Campaign No. 2021110005 December, 2021

SUBJECT: **Model 447 Metris, Model Year 2021**  
**Replace Certain Seat Belts**

S91.40-A023-76

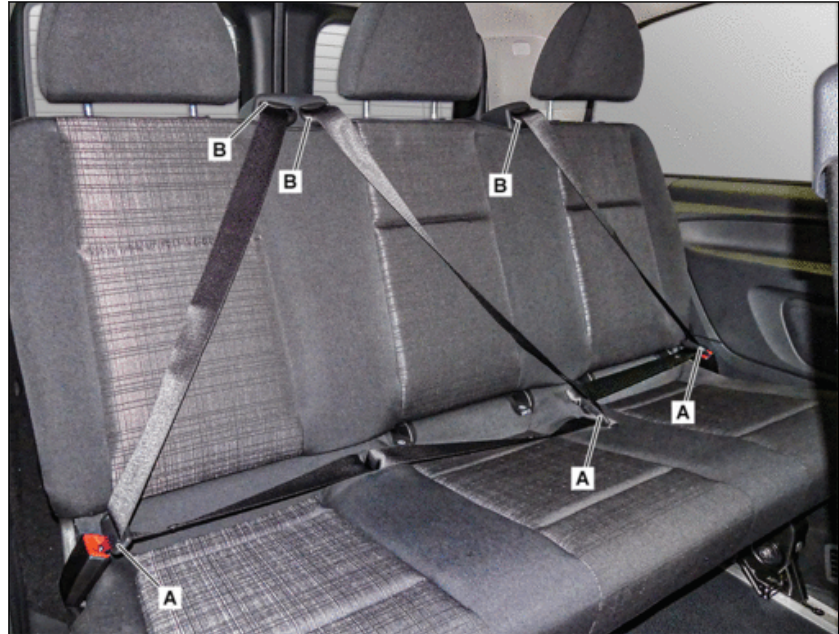
<b>Caution</b>	<b>Risk of injury.</b> Injury may result when the tension in the spring in the automatic belt retractor is released.	Never disassemble automatic belt retractors.	AS91.00-Z-0002-01A
<b>Notice</b>	Notes on carrying out repair work in the vehicle interior		AH68.00-D-0001-01KOS
	<b>Check</b>		
1	Check if vehicle is affected by measure.	Affected vehicles: Check child seat safety feature of seat belts in passenger compartment (code: VS2KISIGUR)  Always check ASRA for the current OP-Code times. Labor times are subject to change and updates may not be reflected in this document.	SM91.40-S-0048-01AAA
	<b>Check</b>		
2	Insert seat belt tongue (A) into respective seat belt buckle in passenger compartment.		
3	Pull seat belt completely out of belt sash guide (B) to end stop.	 <b>The seat belt must be fully pulled out all the way to the end stop.</b>

4	Allow seat belt to slowly roll in again automatically up to the end.	<p>Clip: Check child seat safety feature of seat belts in passenger compartment (code: VS2KISIGUR)</p> <p><b>i</b> Seat belt tongue (A) remains engaged.</p> <p><b>i</b> <b>A significant rattling noise can be heard from the area of the seat belt retractor when the seat belt is rolling in.</b></p> <p>The rattling noise indicates that the child safety lock is activated.</p>	GB91.40-S-0000-01A
5	Slowly and carefully attempt to pull seat belt out of belt sash guide (B).	<p><b>i</b> Do not perform any sudden pulling movements.</p> <p><b>i</b> <b>It must not be possible to pull out the seat belt; it must remain engaged.</b></p>	
6	Open seat belt buckle and allow seat belt to completely retract.		
7	Repeat operation steps 2 to 6 a total of 5 times per seat belt in passenger compartment.	<p>If function of seat belts is OK for 5 repetitions (see operation steps 2 to 6),</p> <p style="text-align: center;">↓</p> <p>child safety locks of seat belts are OK, vehicle can be handed over to customer.</p> <p>If function of seat belts is not OK for one repetition (see operation steps 2 to 6),</p> <p style="text-align: center;">↓</p> <p>replace respective seat belt. Remove/install seat belts for passenger bench seat Model 447</p>	AR91.40-S-1206EE
